In the Matter of)
)
Motorola Global)
Communications, Inc.)
Application for Authority to)
Construct, Launch, and Operate)
the Celestri Satellite System)

COMMENTS OF LORAL SPACE & COMMUNICATIONS LTD.

Appendix A - Interference Analysis

Figure 2-4
Time History of Interference from Celestri LEO System
into GSO Network Without Mitigation

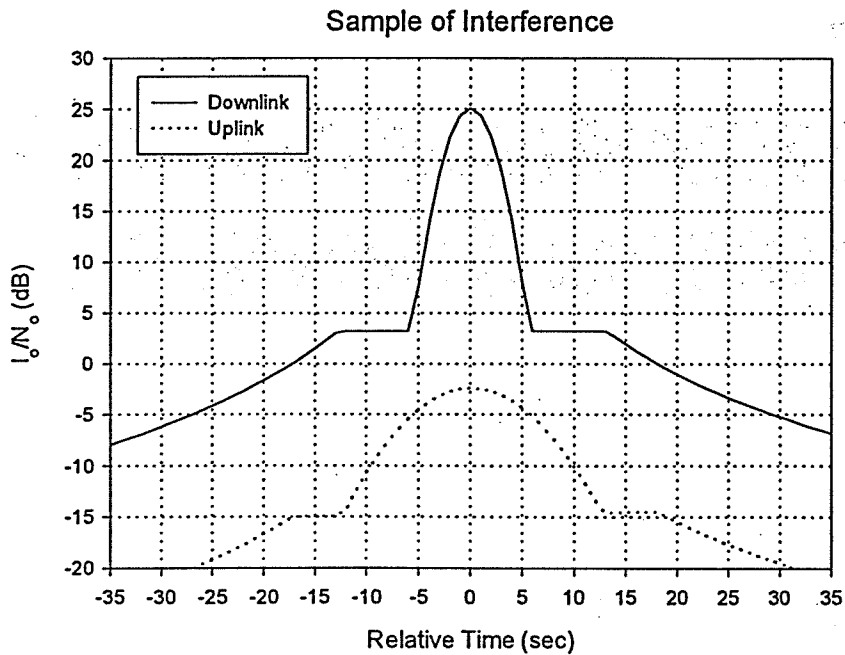
On page 8 of the Celestri Application Figure 2-4 Motorola provides a sample of "time history of interference from Celestri LEO System into GSO Network without Mitigation." This is a graph of Interference to a reference Noise Density (Io/No) as function of time for downlink and uplink. A copy of this graph is shown below in Figure 2-4.

The Noise Density reference is reportedly taken from the example GSO system referred to in Table 2-1 and Table 2-2. However, it is not clear that this is the case because Motorola notes on page 7 of its proposal that the 0 dB level referred to in Figures 2-5 and 2-6 is only for illustration purposes.

Figure 2-10
 Time History of Interference from Celestri LEO System
 into GSO Network

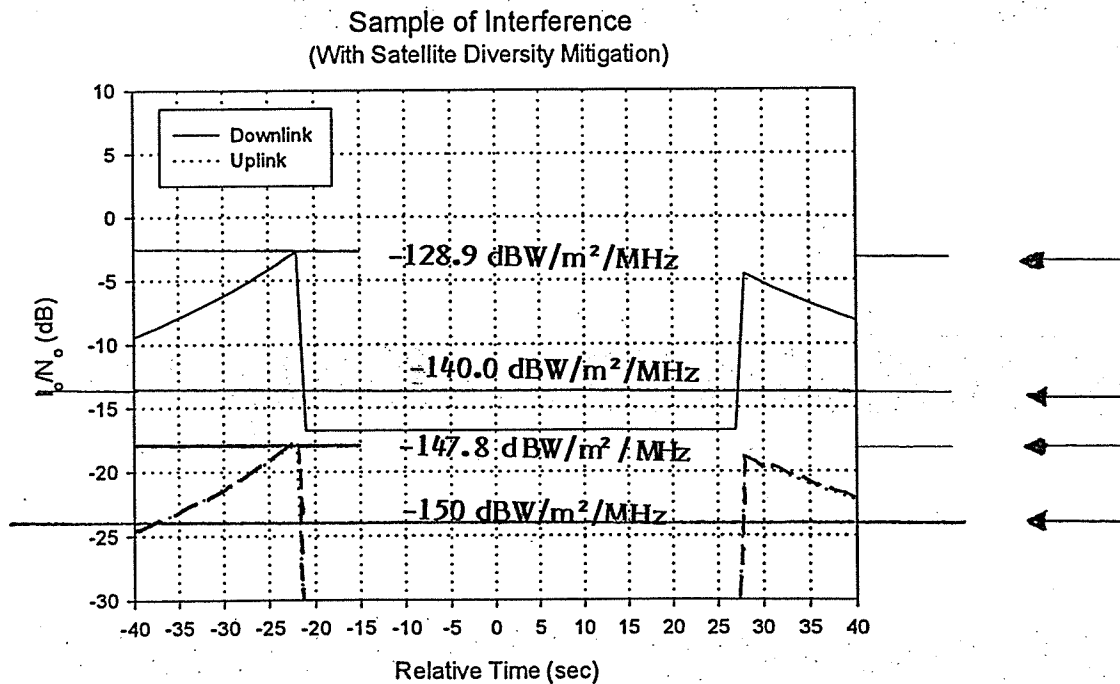
On page 12, Figure 2-10 of its proposal, Motorola provides the same time history when its proposed mitigation technique of cutting off transmission at ± 4 degrees from the GEO arc is applied. Loral has added to Motorola's graph the calculated EPFD/MHz for its 0.3m communication link for both the uplink and downlink from Table 2. For the uplink, the EPFD is -147.1 dBw/m²/MHz and for the downlink the EPFD is -128.9 dBw/m²/MHz. Loral has also added to the graph the WRC-97 COM5-18 & COM5-19 proposed threshold values that should not be exceeded for given percentages of time. If one extends the graph both to the left and the right it shows that the -140 dBw/m²/MHz threshold is exceeded for a total of approximately 60 seconds and the -150 dBw/m²/MHz is exceeded for a much longer time. The actual statistics of how often this happens cannot be determined without a great deal more information from Motorola such as details of the antenna patterns, coverage, and assignment of GSO bands to the individual beams (See Appendix 13). Despite the lack of important details and information in Motorola's proposal, there is sufficient evidence to place Motorola's mitigation design in question and for the Commission to require Motorola to provide additional information and prove that Celestri can operate on a non-interference basis with respect to GSO systems.

The interference mitigation information provided by Celestri is insufficient to conduct a complete analysis. Its proposed parameters, however, seem to far exceed reasonable levels that might permit effective spectrum sharing between Celestri and a GSO system.

The interference analysis simulation performed by Motorola only considers the impact on GSO systems of a single entry system (Celestri). Motorola's analysis must account for additional NGSO systems operating at the same time (e.g., Teledesic GigaLink terminals, future systems, etc.). This requires Motorola to reevaluate its assumptions for link requirements and will cause some redesign of link power or antenna diameter requirements.
